**STAFF RECOMMENDATION**  
**1514 Clayton Avenue**  
**November 20, 2019**

**Application:** New Construction—Infill  
**District:** Belmont-Hillsboro Neighborhood Conservation Zoning Overlay  
**Council District:** 18  
**Base Zoning:** R8  
**Map and Parcel Number:** 11708015600  
**Applicant:** William Smallman  
**Project Lead:** Melissa Sajid, [melissa.sajid@nashville.gov](mailto:melissa.sajid@nashville.gov)

<p><b>Description of Project:</b> The application is to construct a one and one-half story infill building with an attached garage that is located at basement-level.</p> <p><b>Recommendation Summary:</b> Staff recommends approval of the project with the following conditions:</p> <ol style="list-style-type: none"><li>1. The finished floor height shall be consistent with the finished floor heights of the adjacent historic houses, to be verified by MHZC staff in the field;</li><li>2. The front setback shall be consistent with the buildings to either side, to be verified by MHZC staff in the field;</li><li>3. Staff approve the final selections of the roof color, porch floor and steps, porch posts and railings, doors, garage door, walkway, and driveway material;</li><li>4. Sta

LEFT ELEVATION

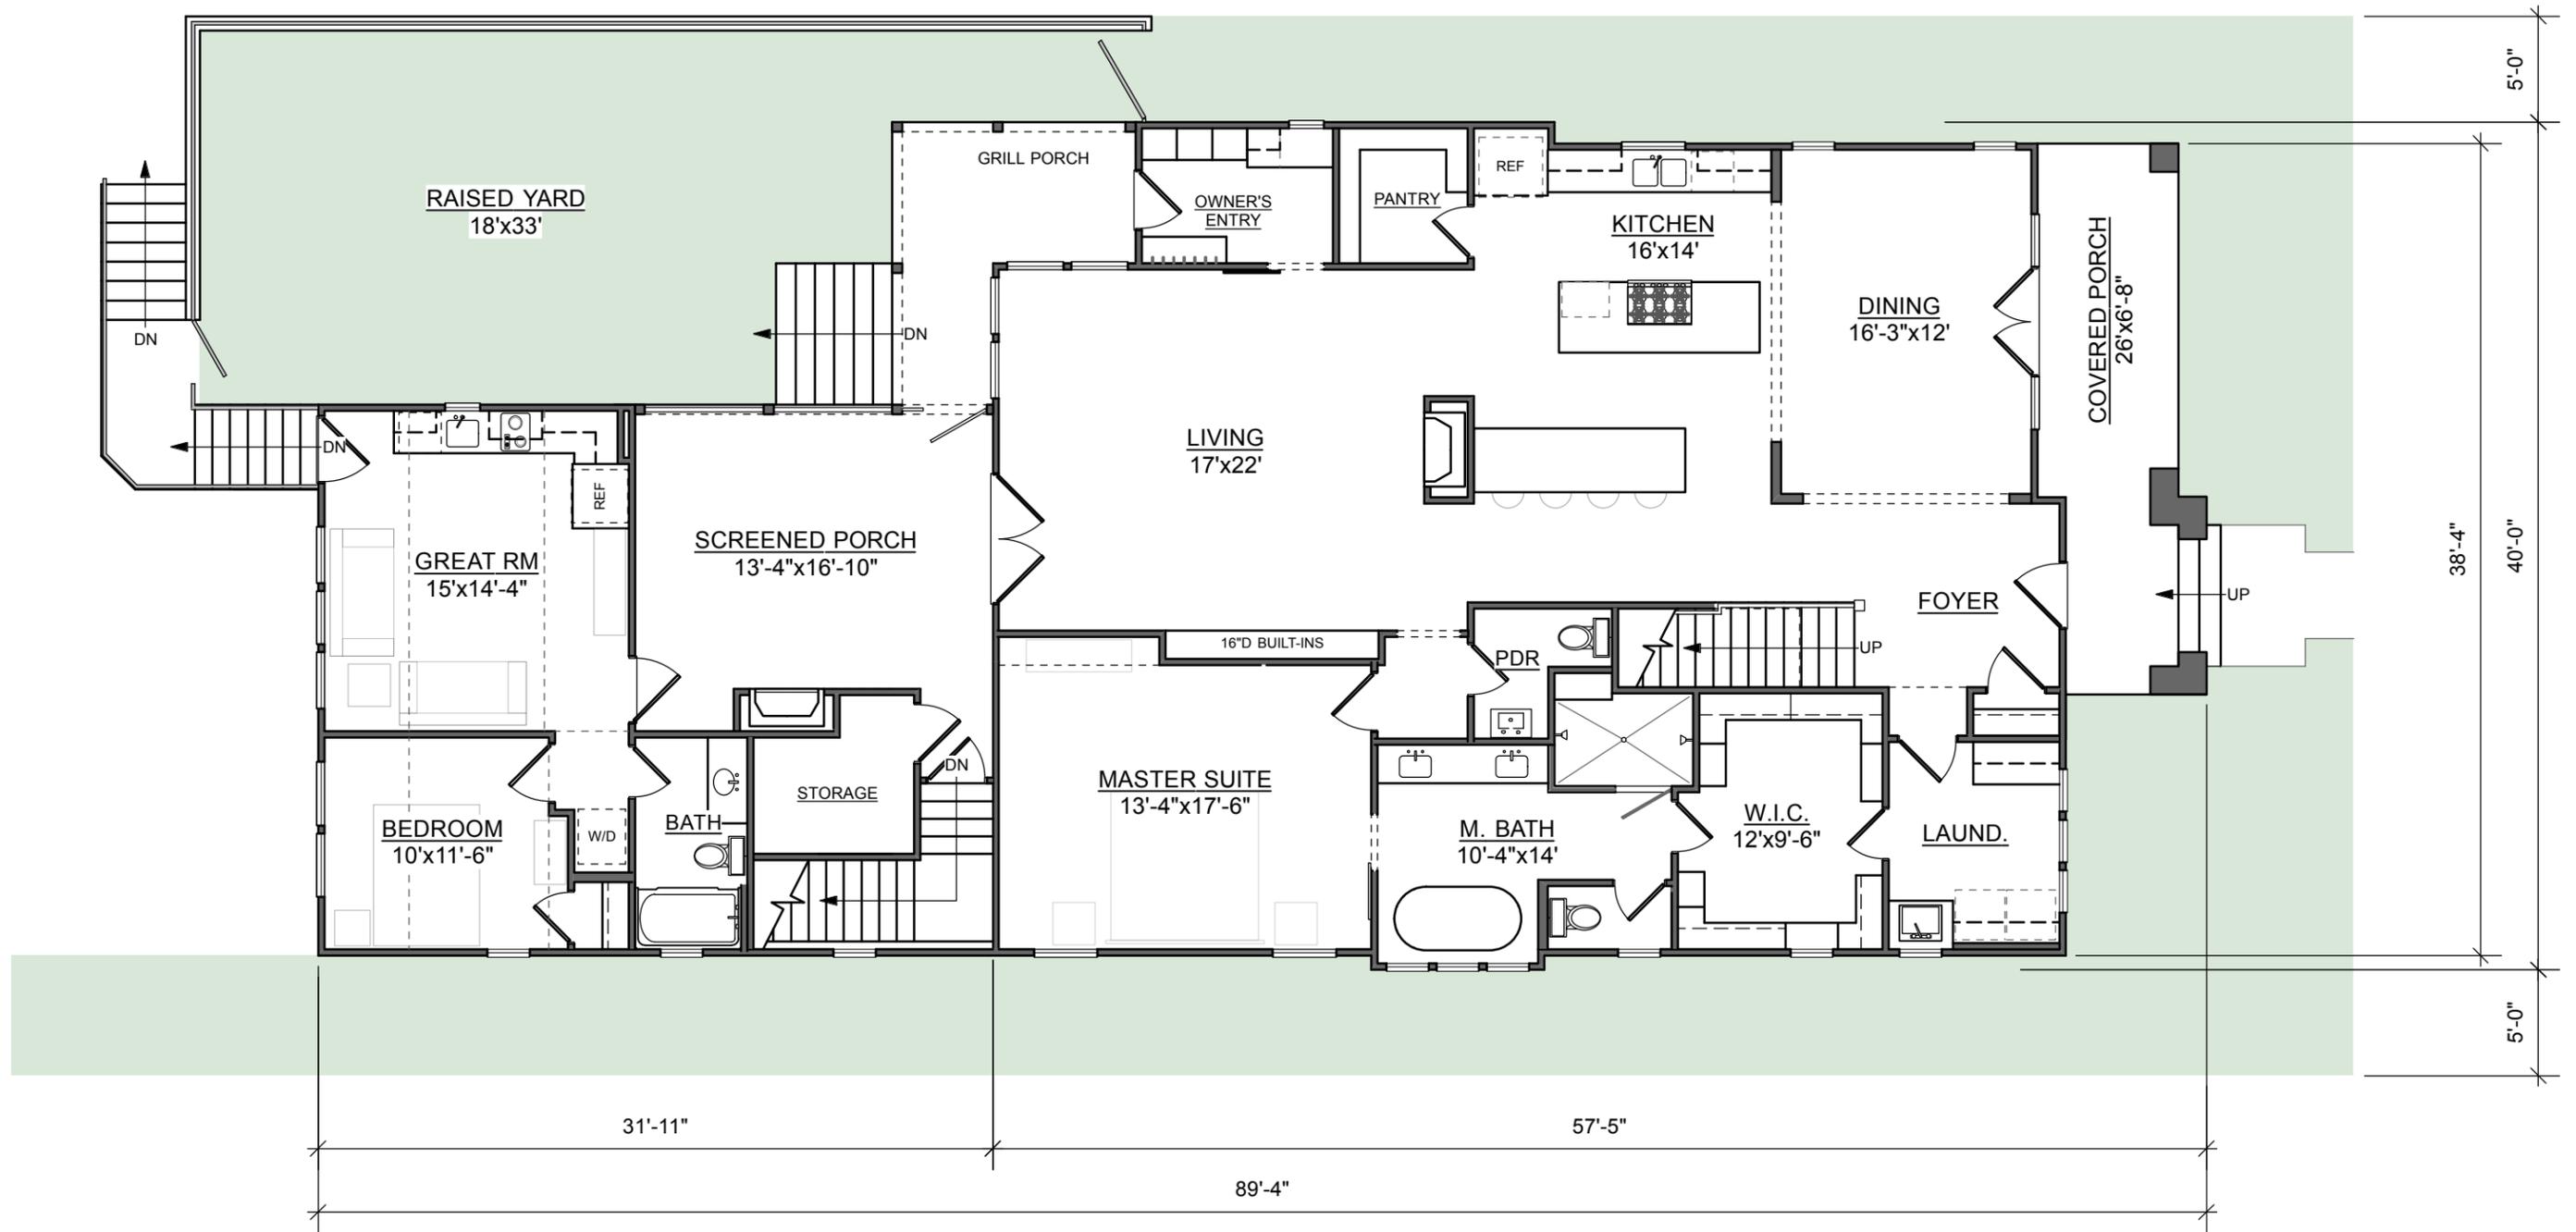
**Proportion and Rhythm of Openings:** Most of the windows on the front and right-side façades of the proposed infill are all generally twice as tall as they are wide, thereby meeting the historic proportions of openings. However, there are six windows on the left side façade that are squares rather than vertically oriented (Figure 2). The three square windows closest to the rear can be appropriate since they are not likely to be visible from the street given their location. The three square windows closest to the front, however, will be highly visible; therefore, staff recommends that they be twice as tall as they are wide to meet the historic proportion of openings. There are no large expanses of wall space without a window or door opening.

Figure 2. Left-side elevation

With the condition that the three windows on the left-side façade nearest to the front be twice as tall as they are wide, staff finds the project's proportion and rhythm of openings can meet Section II.B.1.g.
